SAMPLE DRAWINGS

SUBMITTAL 1

PROJECT:
SAMPLE DRAWINGS

APPROVAL DATE	-
PLOT DATE	07/11/2024
PROJECT NUMBER	P-5567446
ROOM NAME	GENERAL INFO.
SHEET NUMBER	1CS.01

01 LOBBY A105
PLAN VIEW
SCALE: 3/4"=1'-0" ARCH REF.: A10/A605

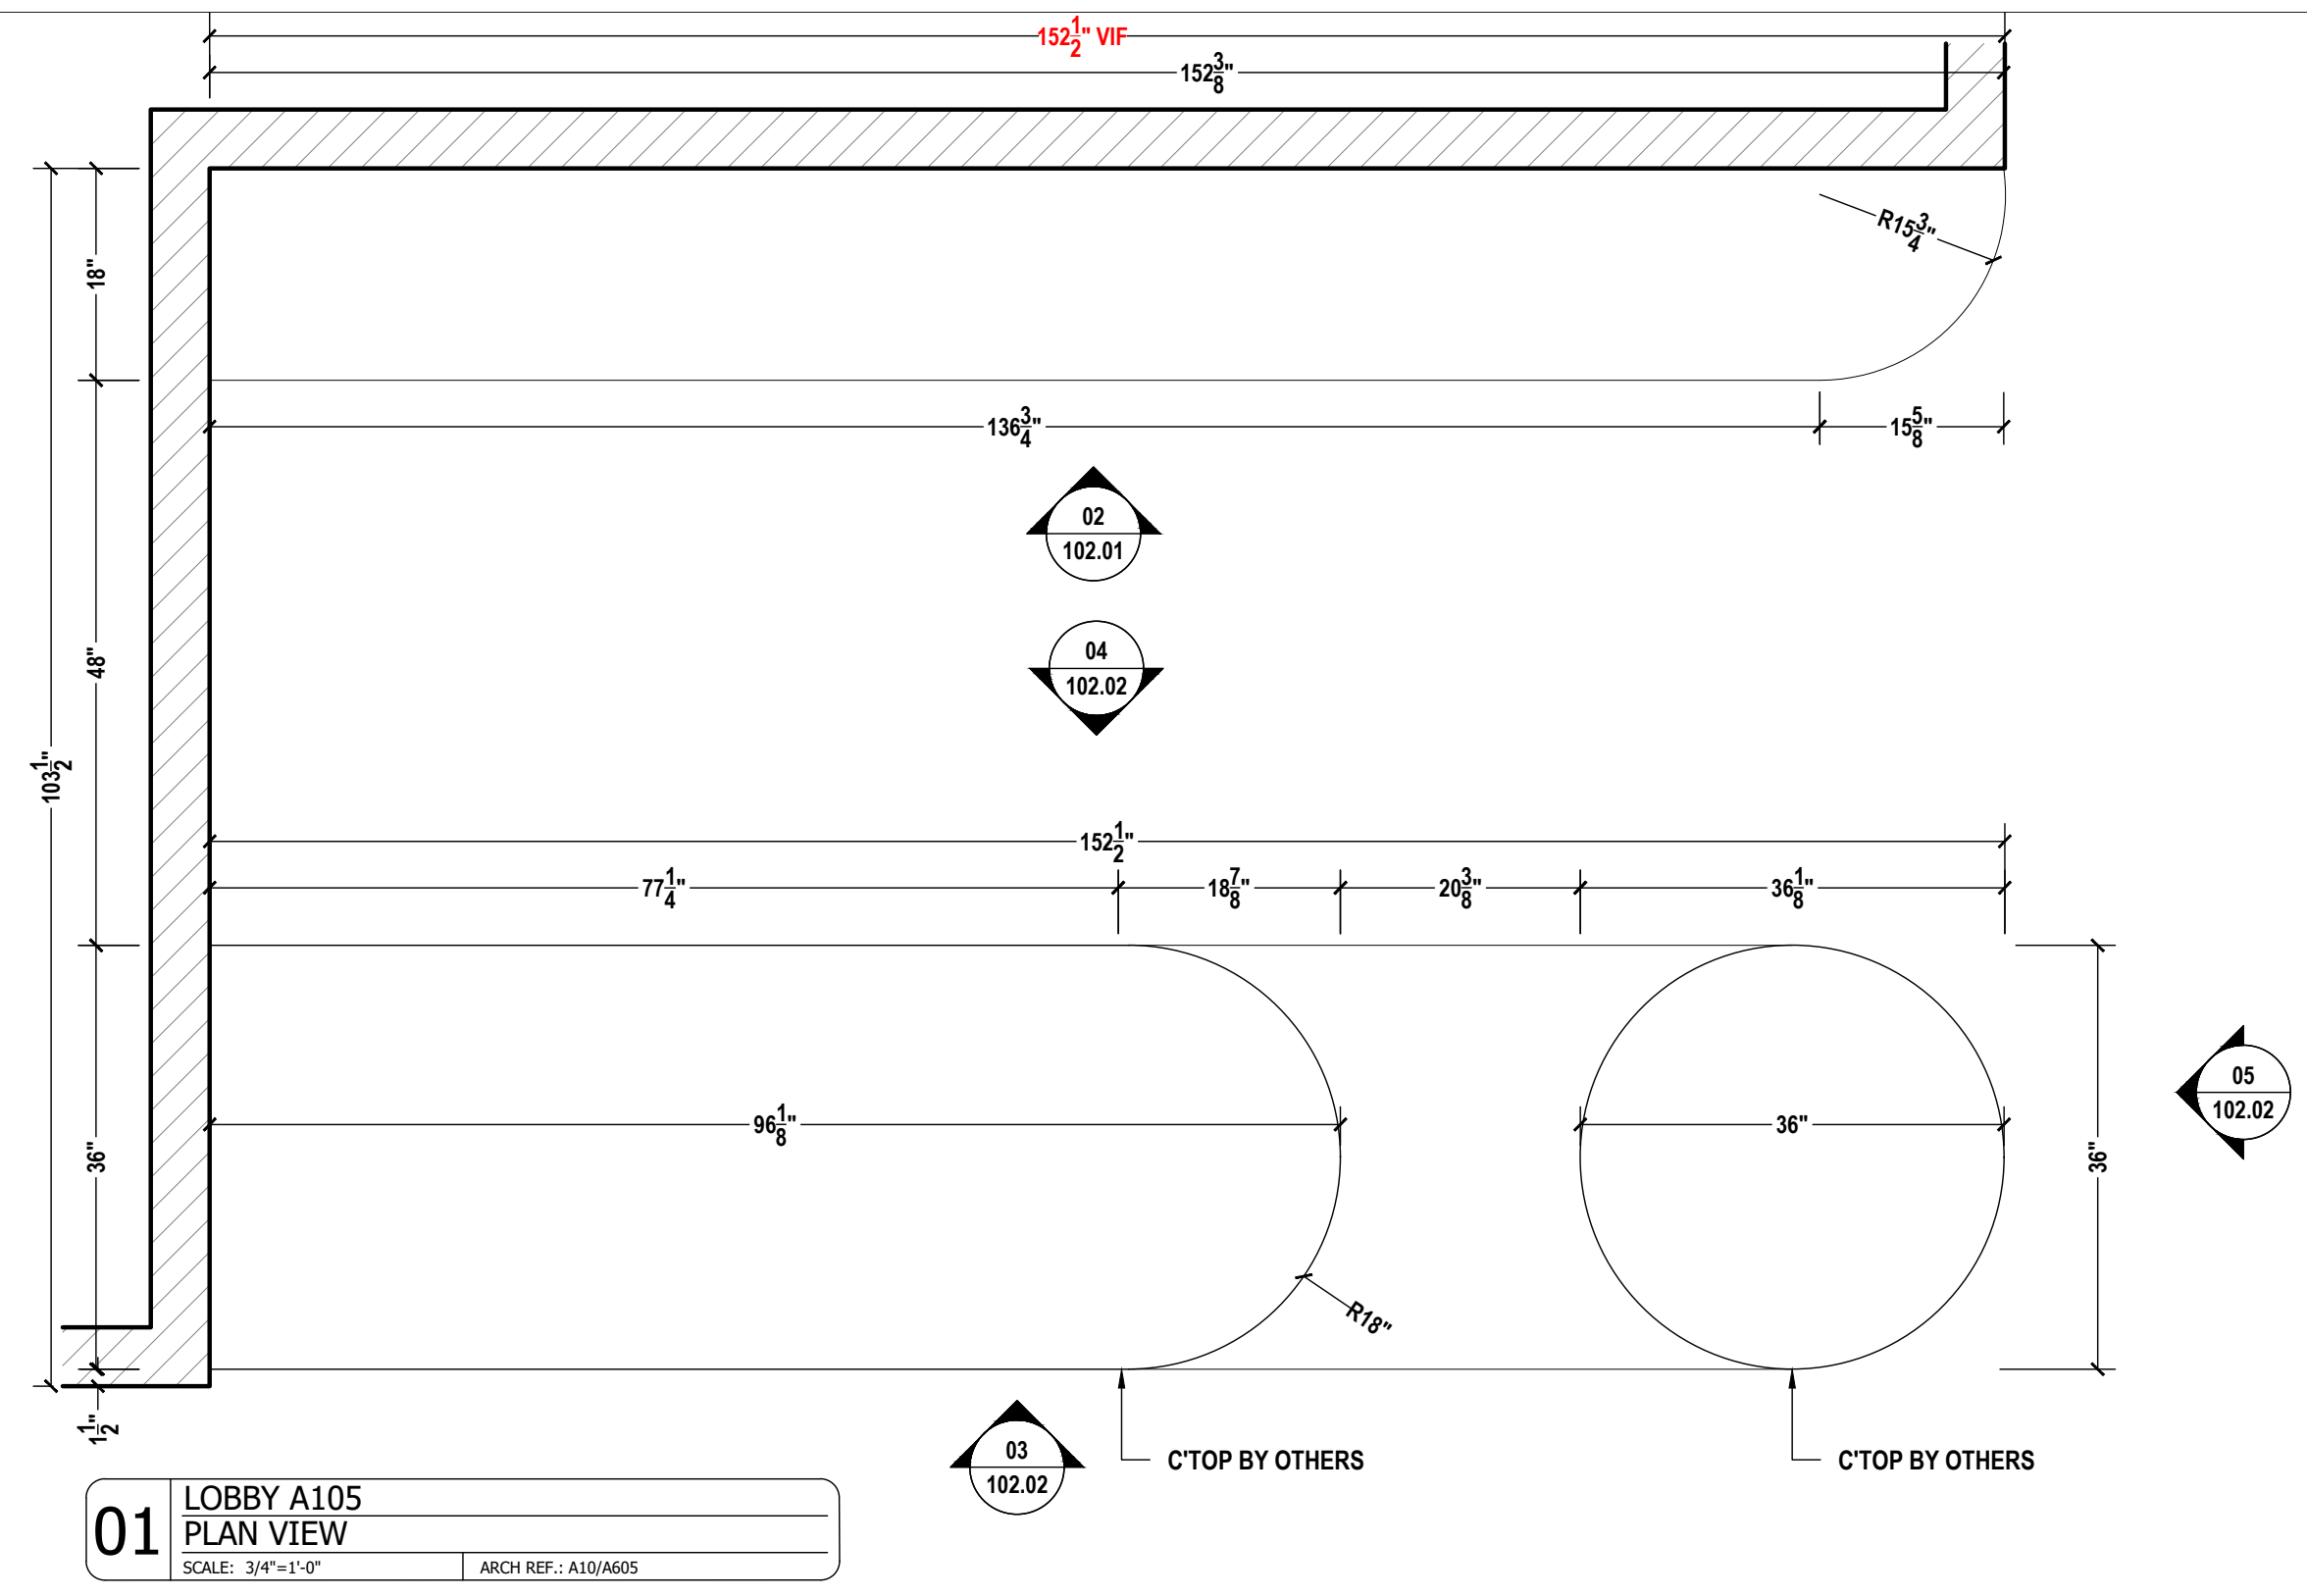
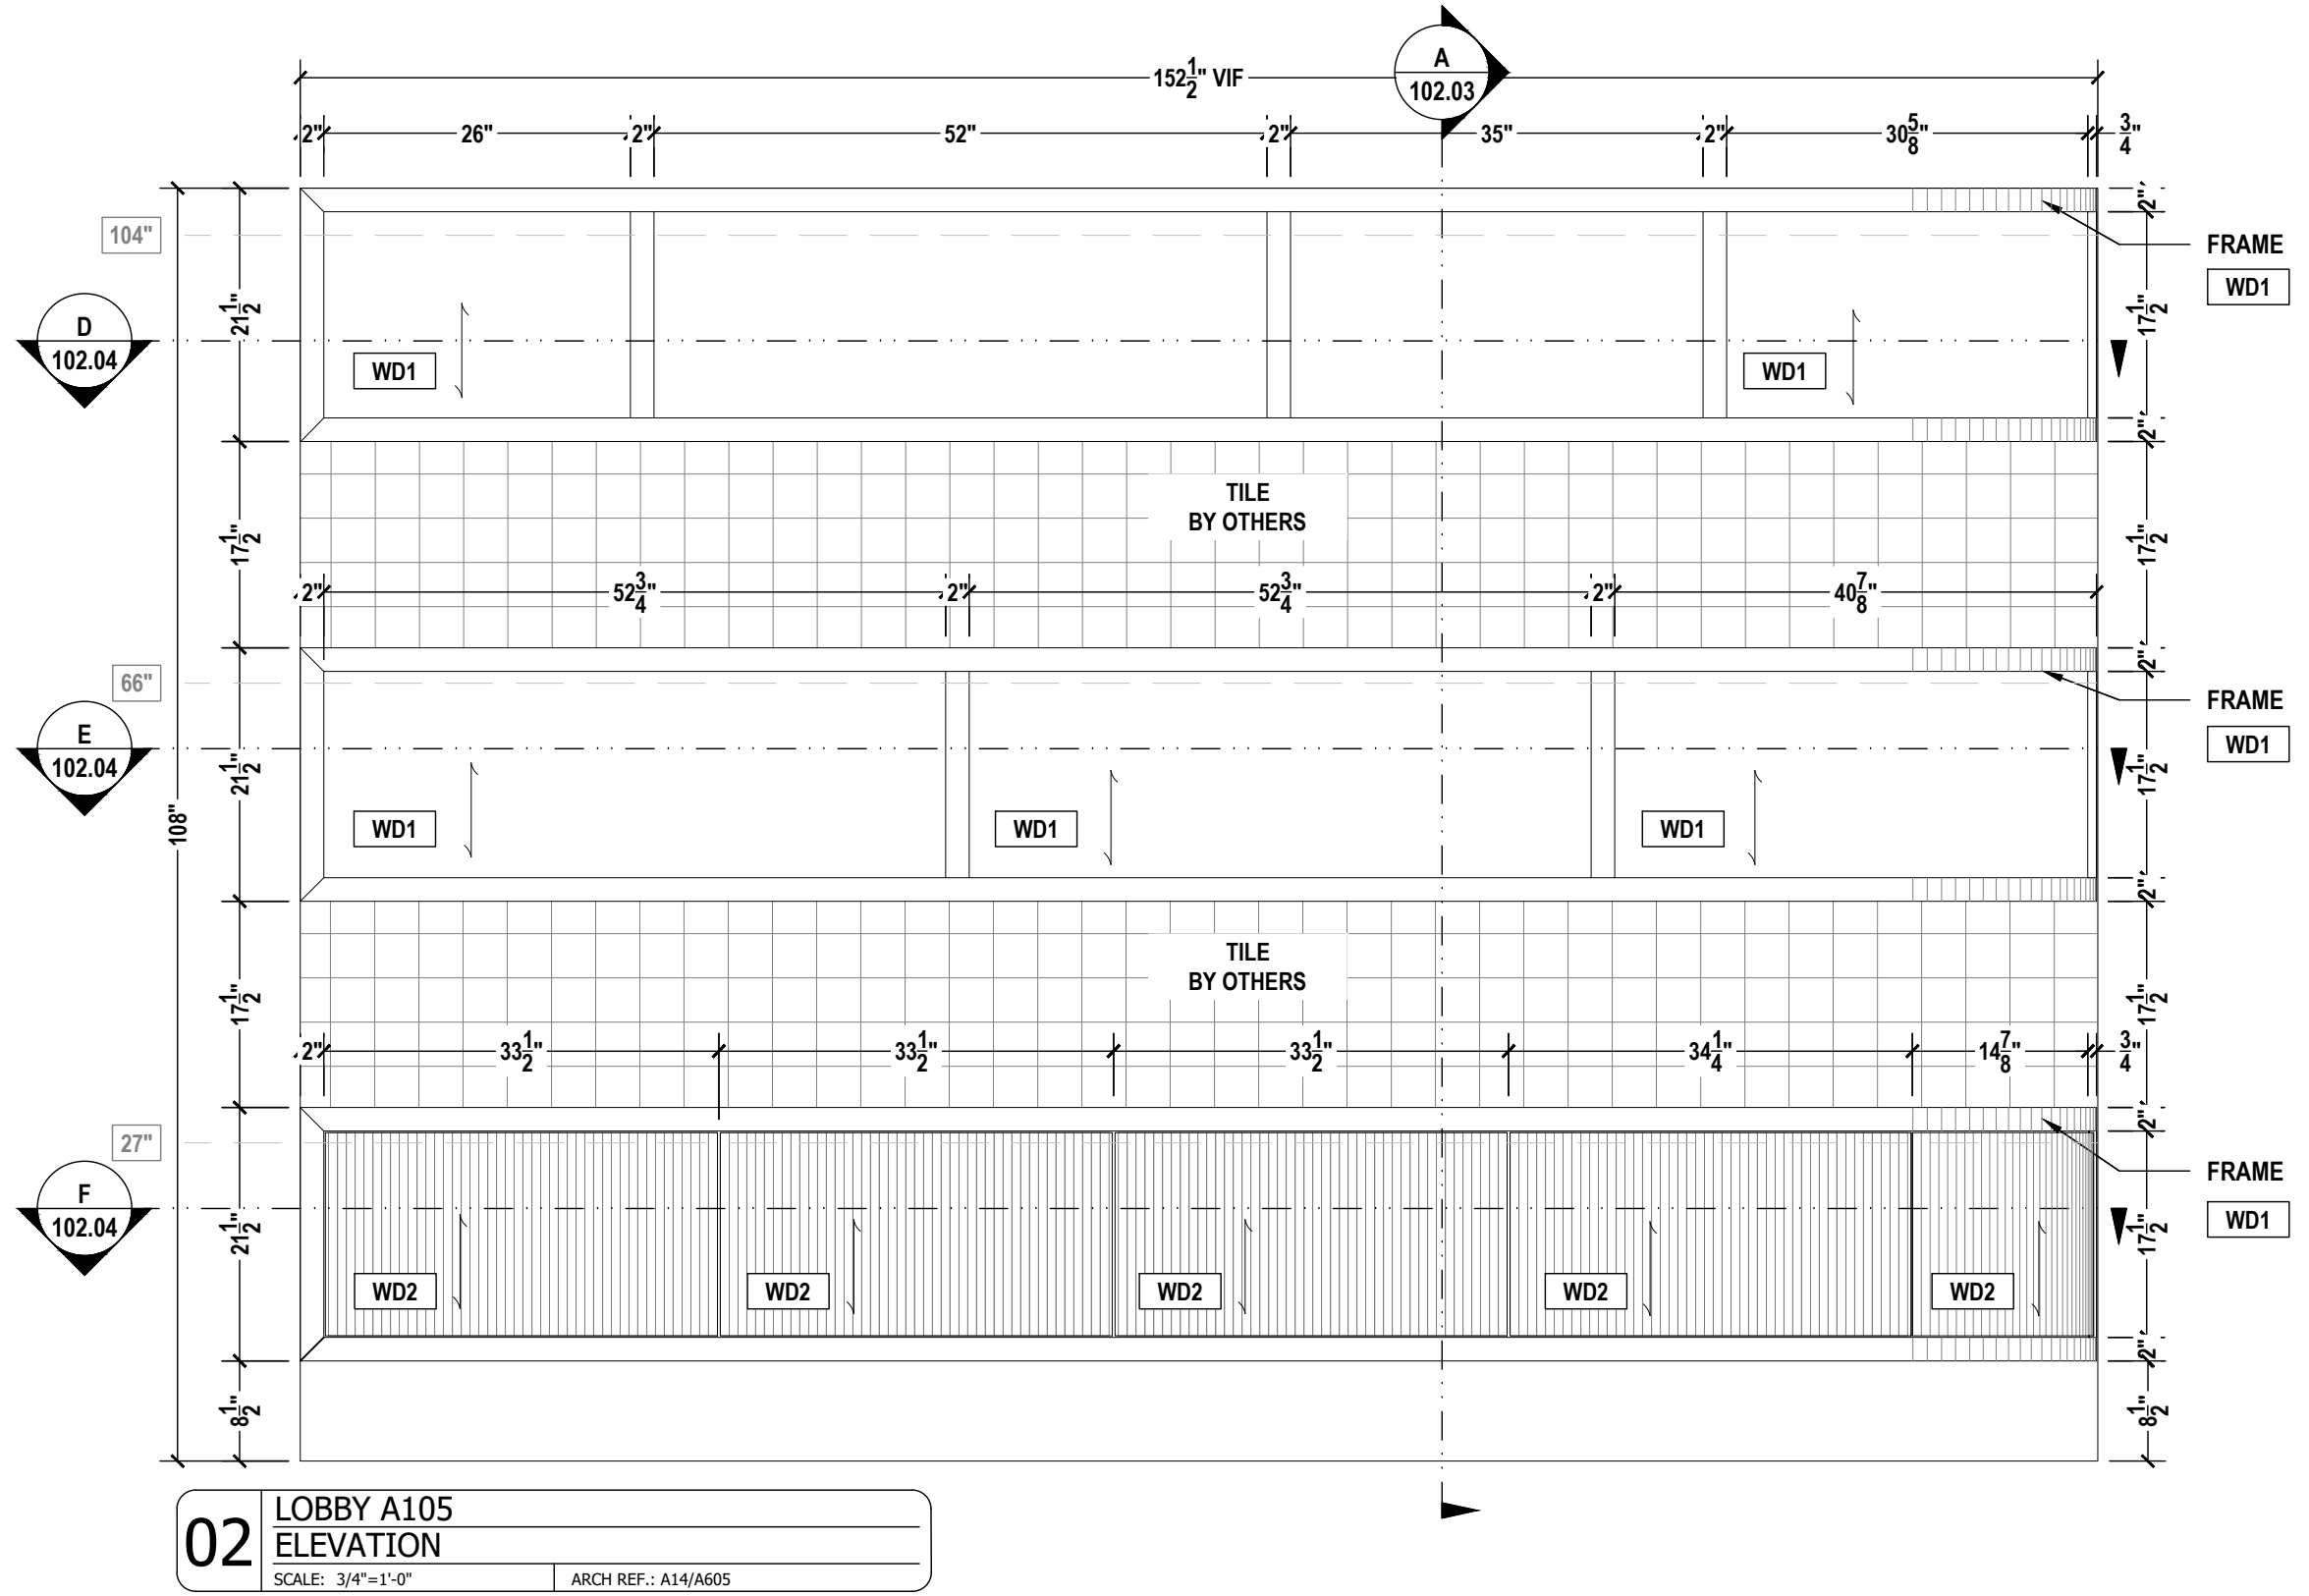
**** NOTE TO ARCH AND G.C. ****
 REFERENCE RFI LIST ON SHEET 1CS.02
 PLEASE PROVIDE WD2 SPECIFICATIONS.
